SDP-0315-09

Purpose of Application	Notice Dates	
Add a new townhouse architectural model, the Haverford Homes Coltrane model.	Informational Mailing:	03/20/18
	Acceptance Mailing:	04/20/18
	Sign Posting Deadline:	05/07/18

SUBJECT: Specific Design Plan SDP-0315-09
Beech Tree, East Village, Sections 4 and 5

OVERALL SITE PLAN

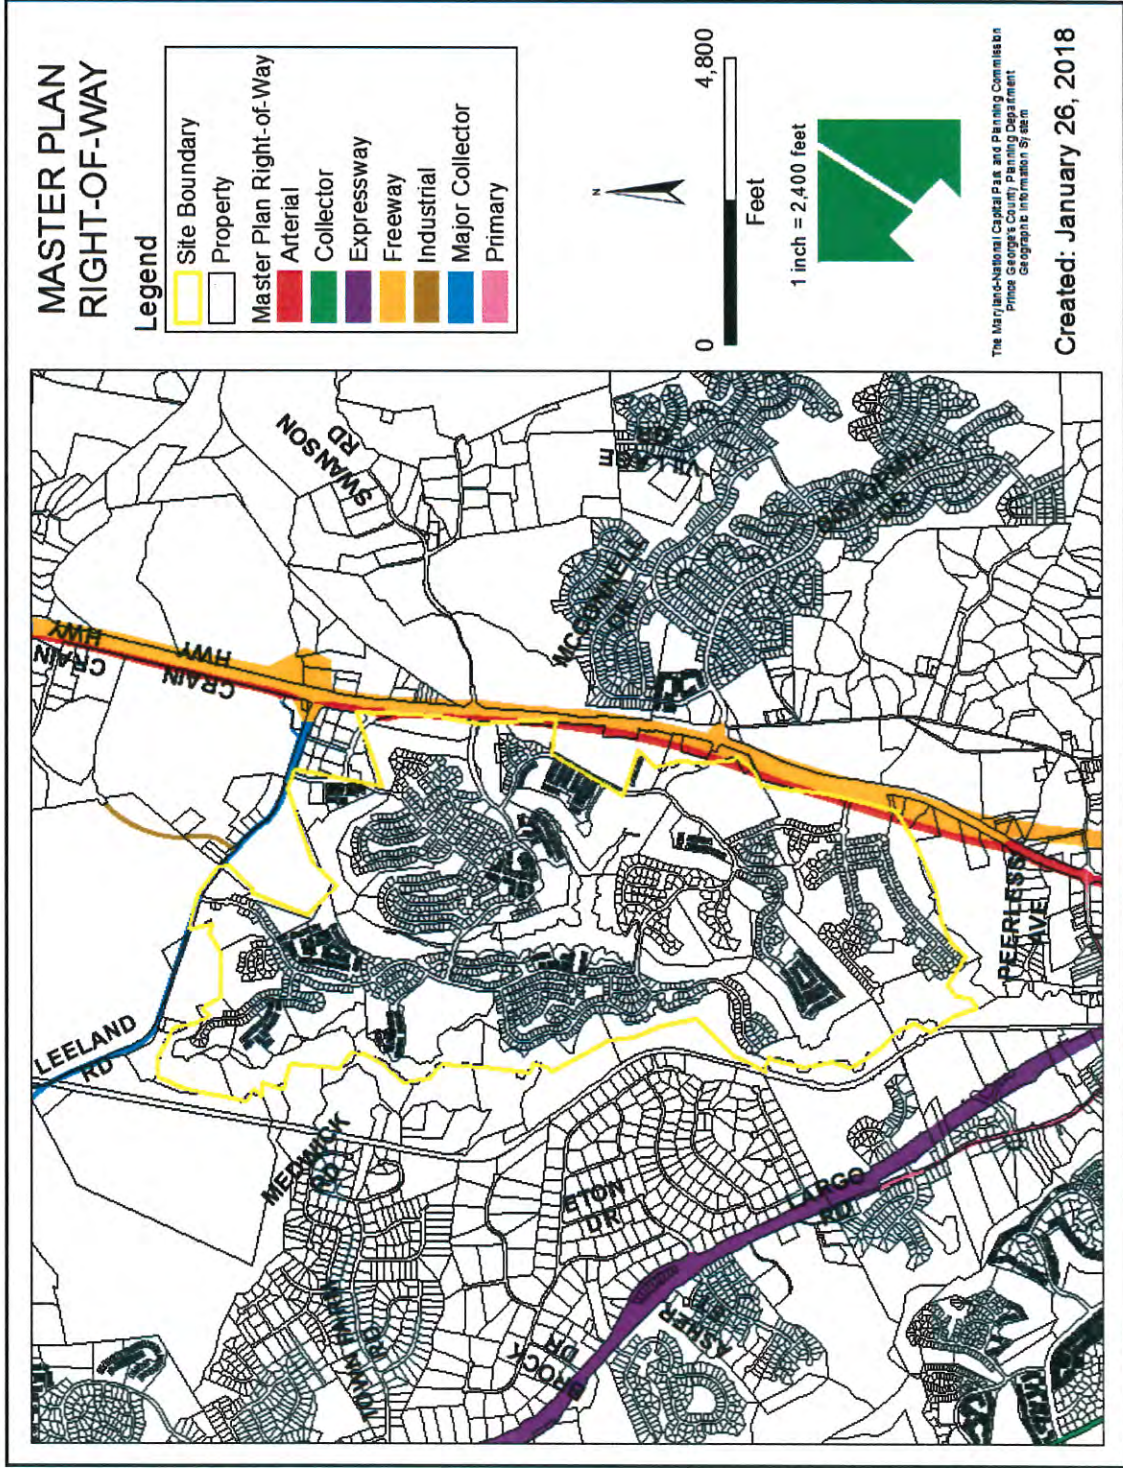
The cover sheet of the SDP contains an overall plan of the Beech Tree project on which is shown phase or section numbers and a chart of approved or submitted SDP numbers.
